VERMONT YANKEE NUCLEAR POWER CORPORATION

FVY 84-95

Subject: Supplemental Information Regarding the Vermont Yankee 1984
Refuel Outage Augmented In-Service Inspection Program

TABLE V - REVISION 1

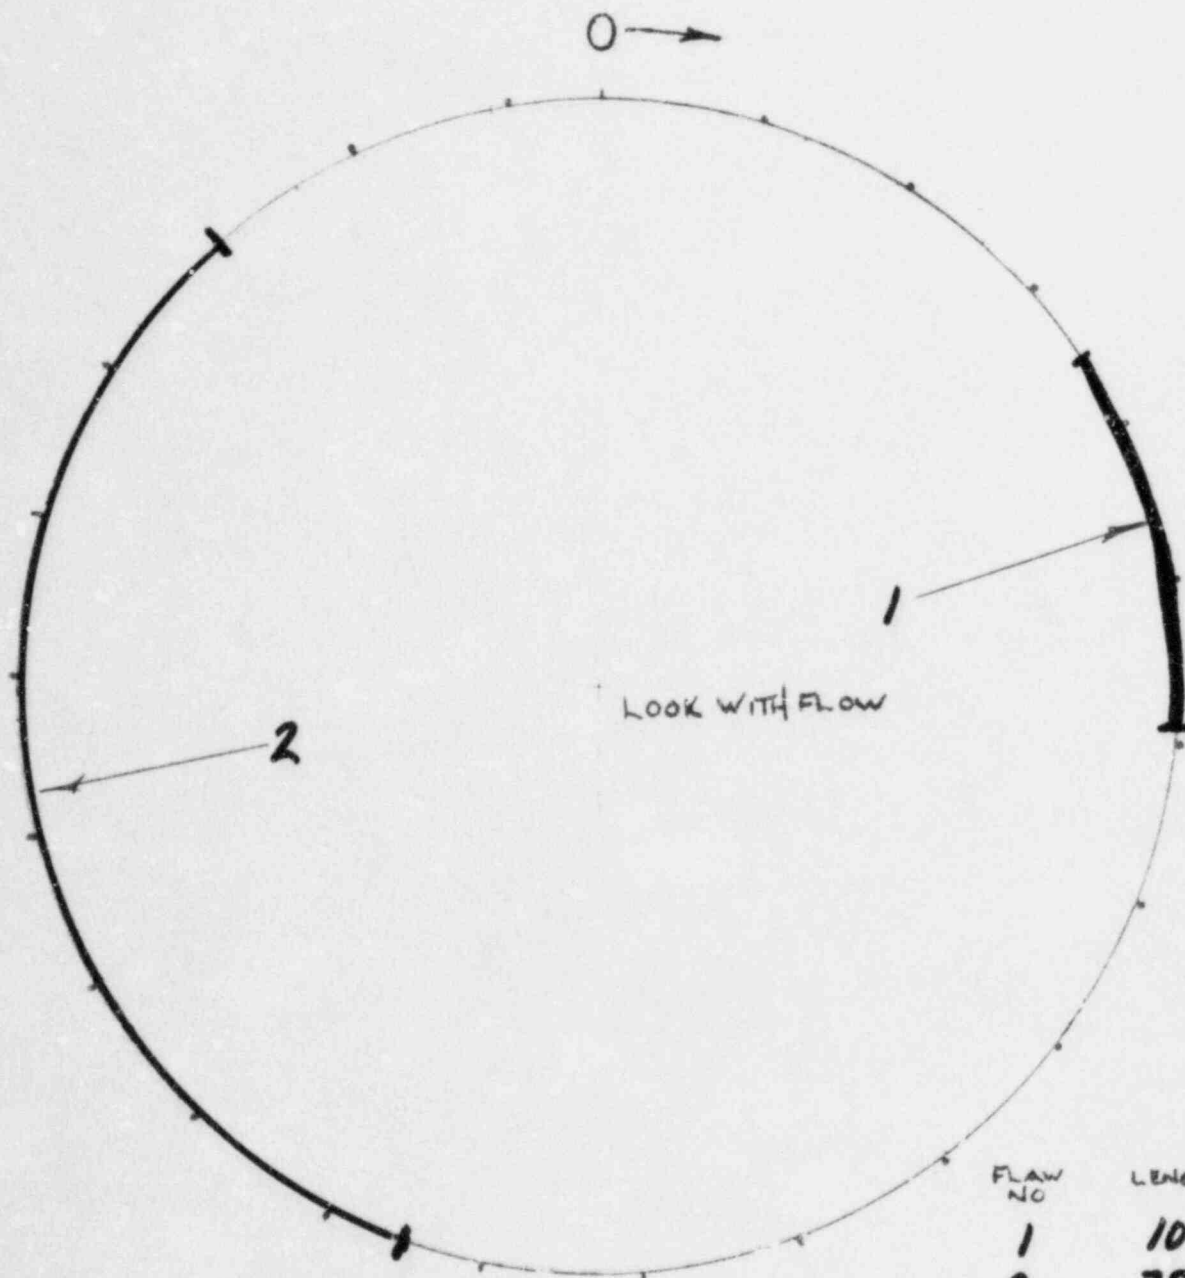
5. Table V of our Final Report depicts a comparison of 1983 to 1984 inspection results. Your Staff requested that we revise the third column of this Table to reflect total length of all circumferential indications, regardless of separation.

Table V of our Final Report has been revised and is attached to this letter (see Table V - Revision 1).

(1) L - Total length of all circumferential indications.

(2) A/T - Flaw depth as a percentage of wall thickness (based on weighted average depths of all flaws).

VY 1983 FLAW
SUMMARYWELD
NO.

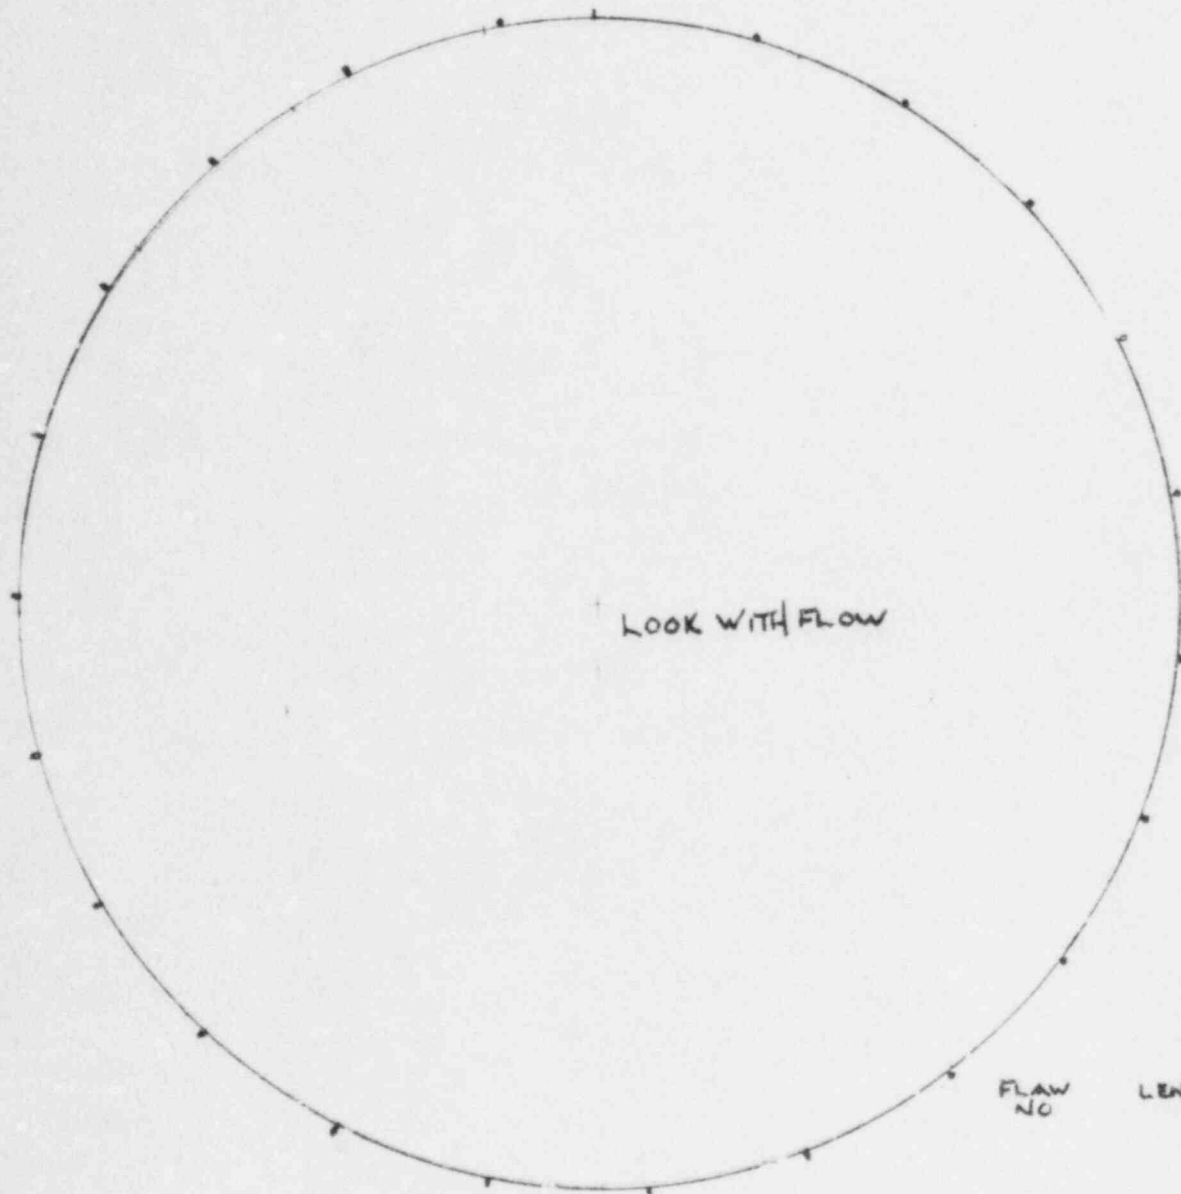
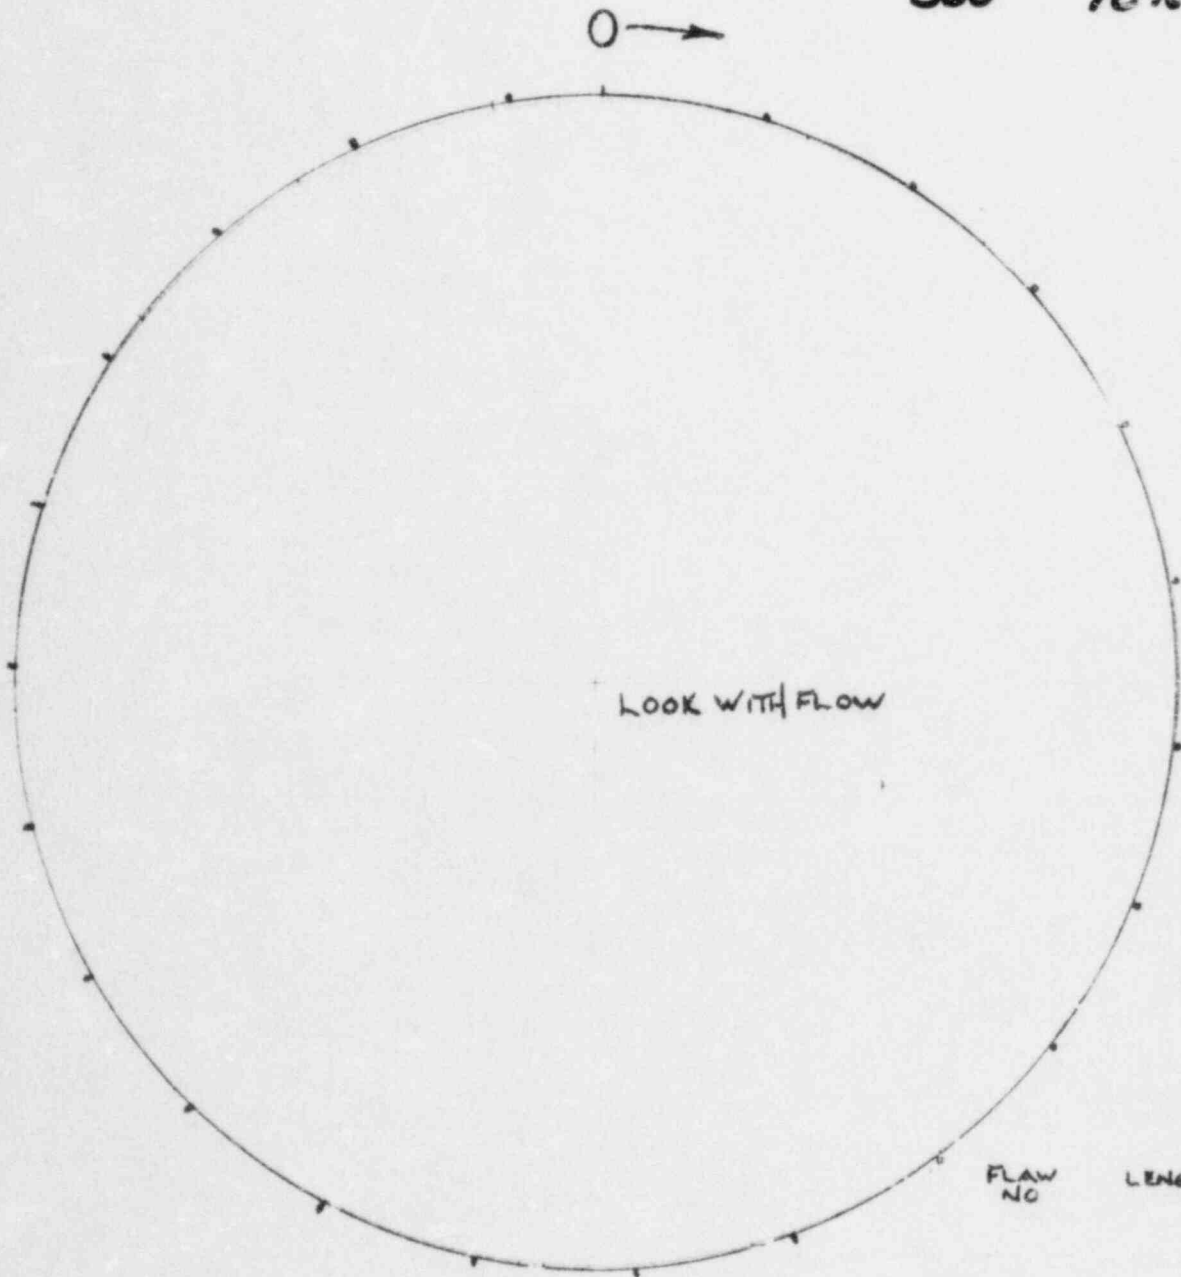
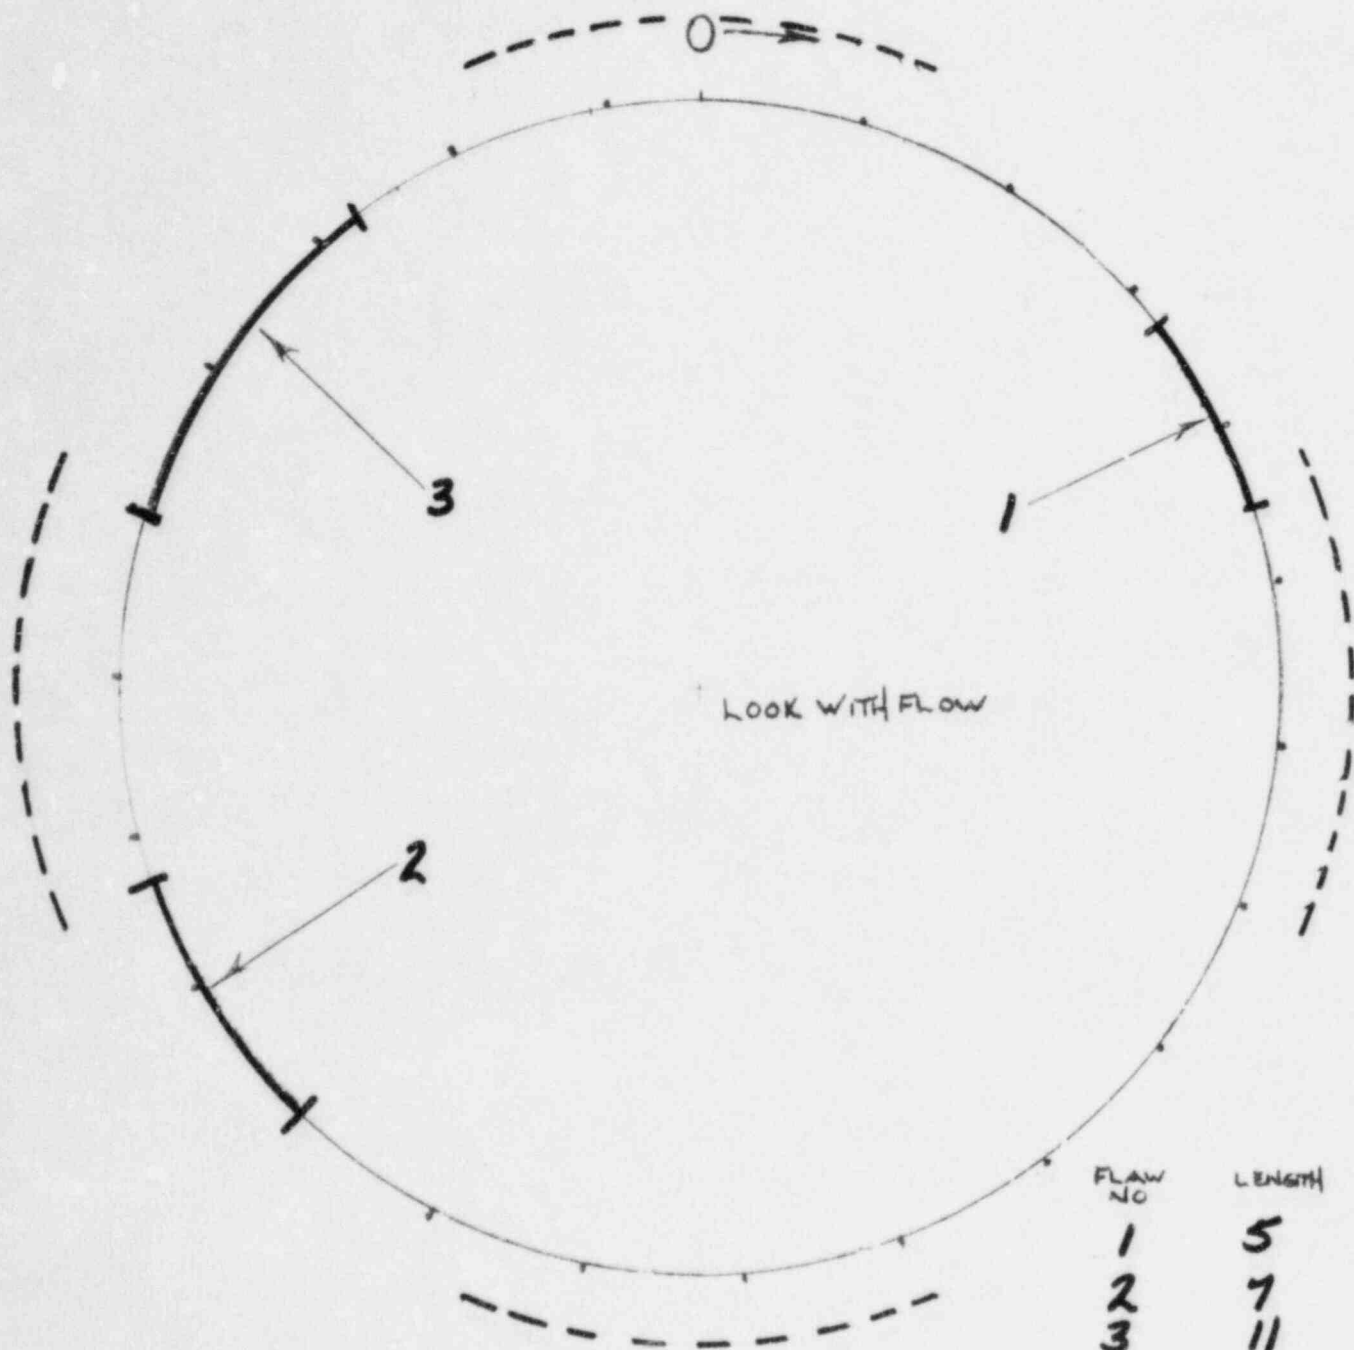
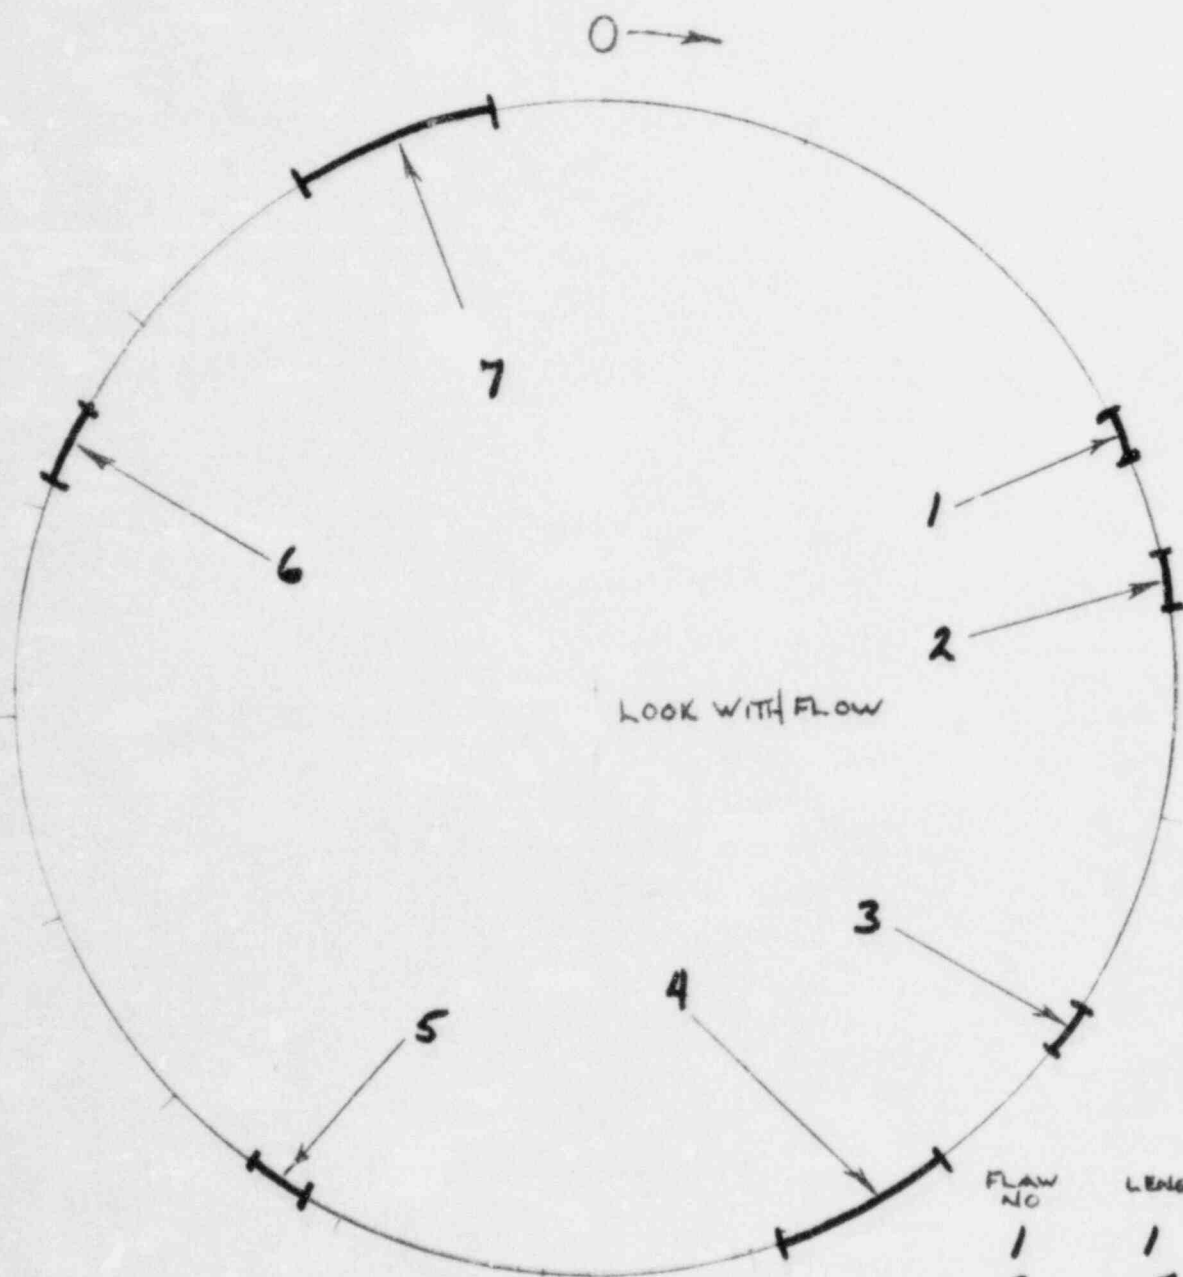
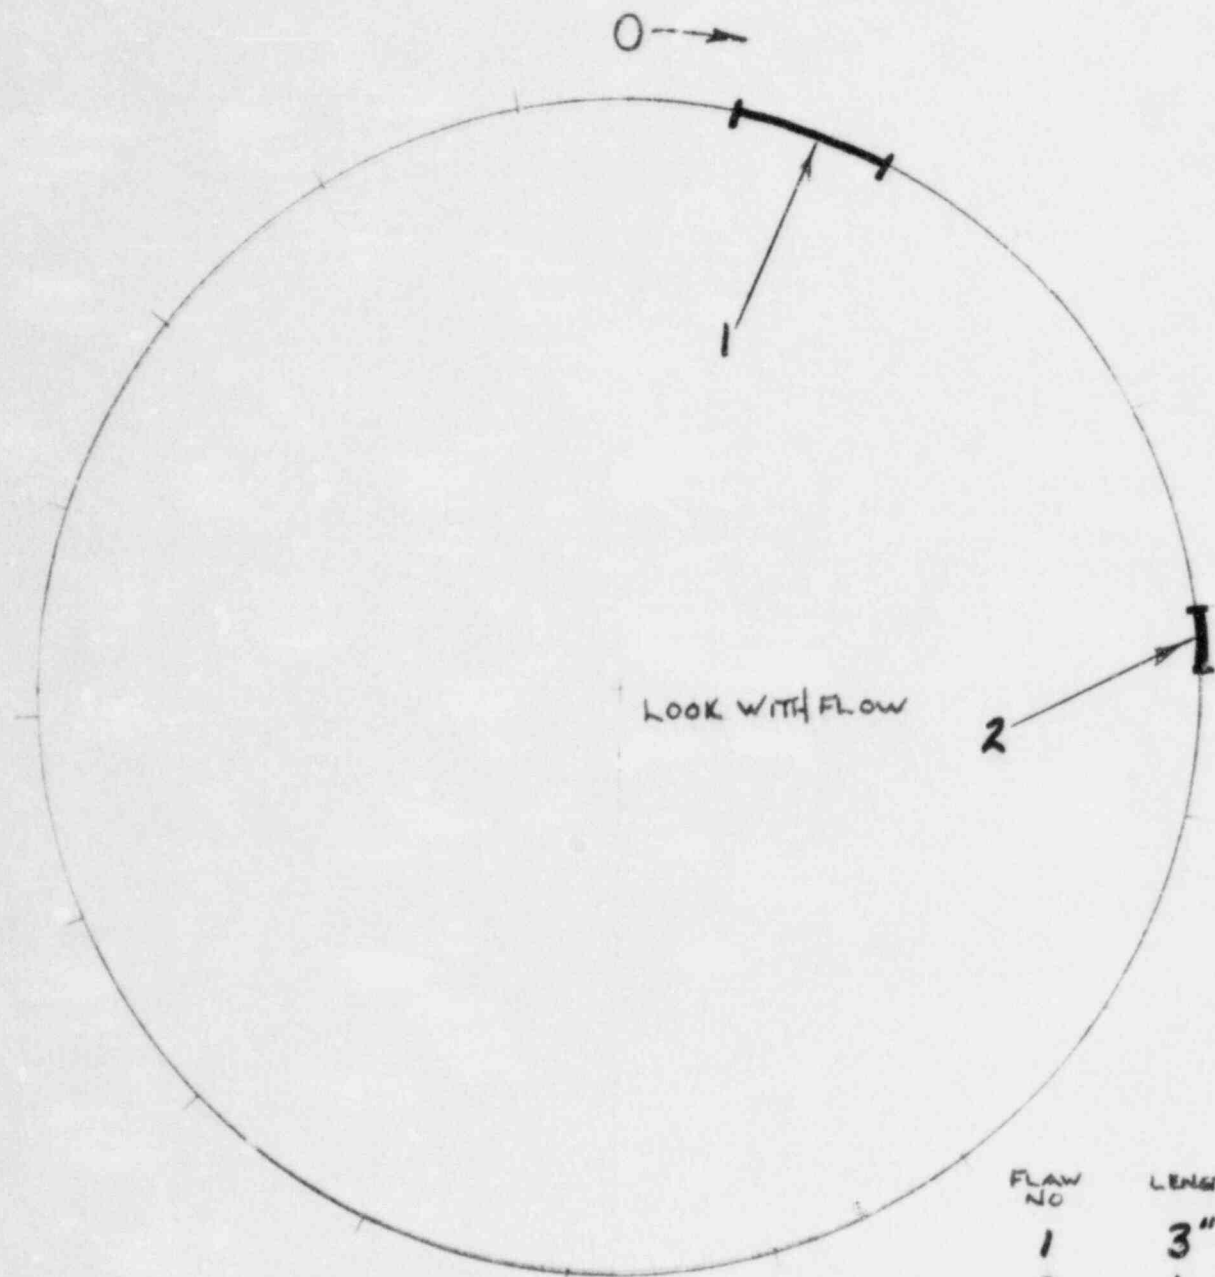
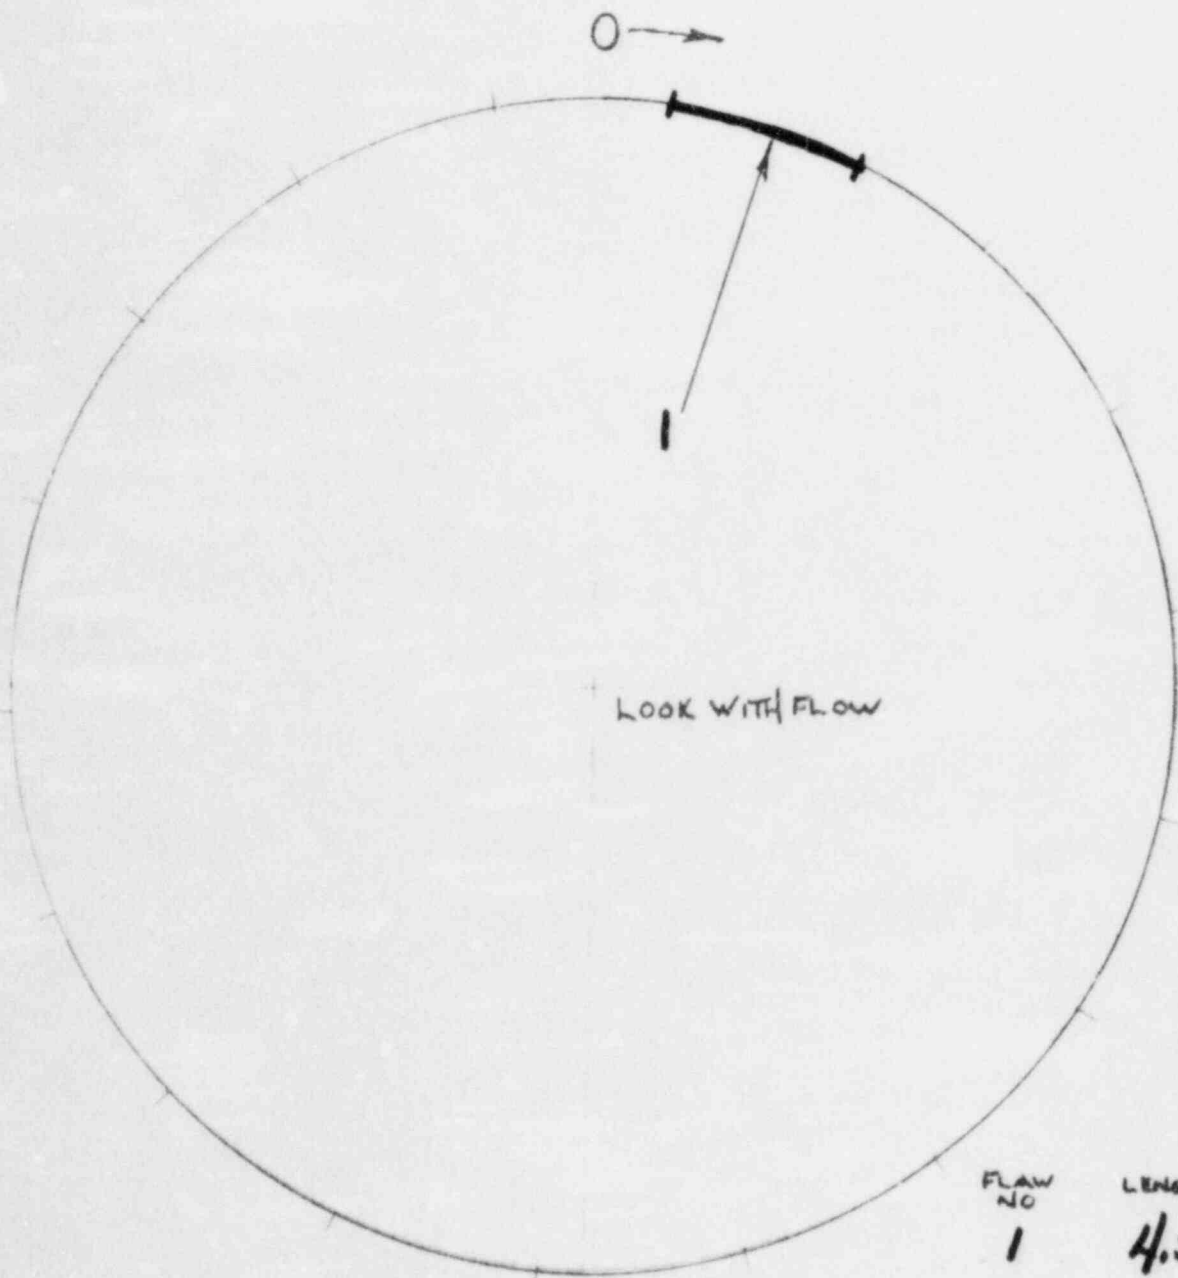
4. Table VIII of our Final Report provides a summary of weld joint flaws for 1983. Your Staff requested that we submit weld flaw diagrams for 1983 similar to those provided in Table IX of our Final Report.

Your Staff also requested that we describe the criteria for how we determined the flaw lengths for 1983. This information is provided in Attachment A to our Final Report; however, additional clarification was requested.

The requested weld joint flaw diagrams for 1983 are attached to this letter. These diagrams are supplements of Table VIII of our Final Report.

It should be noted that the 1983 flaw summary diagrams are reconstructions called "flaws" from 1983 examinations. In comparing the 1983 flaw diagram to the 1984 diagram, it must be recognized that the 0° points are not exact. In addition, neither the 1983 or the 1984 summary diagrams contain all recorded indications, but rather, they represent the end results of the detection and discrimination processes.

In 1983, the procedural requirements (which served as the basis for the I&E Bulletin 83-02 Qualification) were to carry the linear extent of an indication to the point where its amplitude dropped to one-half the maximum amplitude. In instances where indications continued for any distance at less than one-half maximum amplitude, the indication was continued over the full extent until the indication definitively dropped.
